# Work Order ID 59679

Item Name: Head Rest

DESIGN <i>[Signature]</i>	DRAWN BY <i>[Signature]</i>	<b>DART AEROSPACE LTD</b> HAWKESBURY, ONTARIO, CANADA	
CHECKED <i>PH</i>	APPROVED <i>[Signature]</i>	DRAWING NO. <b>D3303</b>	REV. B SHEET 1 OF 4
DATE <b>06.08.17</b>	TITLE <b>HEAD REST</b>		SCALE 1:3
REV A	DATE 04.08.18	DESCRIPTION NEW ISSUE	
B	06.08.17	UPDATED FLAT PATTERN TO FORM PART IN ONE OPERATION USING OFFSET DIE

DRAWING NO. D3303	TITLE HEAD REST	REV. B	<b>DART AEROSPACE LTD ENGINEERING ORDER</b>		D.E.O. NO. D3303-B-1	SHEET NO. SHEET 1 OF 1	SCALE NTS
DRAWN AJS	CHECKED <i>h</i>	MFG. APPR. <i>h</i>	APPROVED <i>h</i>		DE APPR. <i>h</i>		
DATE 08.10.15	DATE <i>08.10.15</i>	DATE <i>08/10/16</i>	DATE <i>08/10/16</i>		DATE <i>08/10/16</i>

*2/10-6-09***D3303-041 HEAD REST**

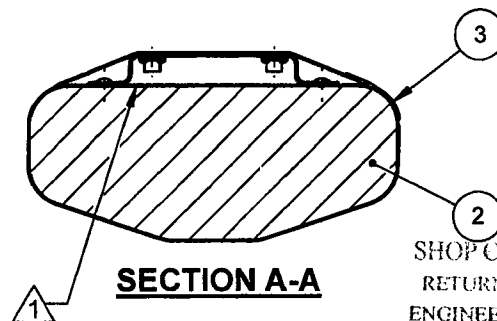
SHEET 1 ADD 1300L ADHESIVE BY 3M TO NOTE 1 AS FOLLOWS:

WAS:

NOTES:

- 1) BOND D3305-1 FOAM TO D3303-043 BRACKET ASSEMBLY USING 3M 1300 ADHESIVE (0.002" TO 0.010" THICK) IN ACCORDANCE WITH MANUFACTURER'S INSTRUCTIONS

SEE NCR 08-069 FOR FURTHER DETAILS

IS:

NOTES:

- 1) BOND D3305-1 FOAM TO D3303-043 BRACKET ASSEMBLY USING 3M 1300 OR 1300L ADHESIVE (0.002" TO 0.010" THICK) IN ACCORDANCE WITH MANUFACTURER'S INSTRUCTIONS
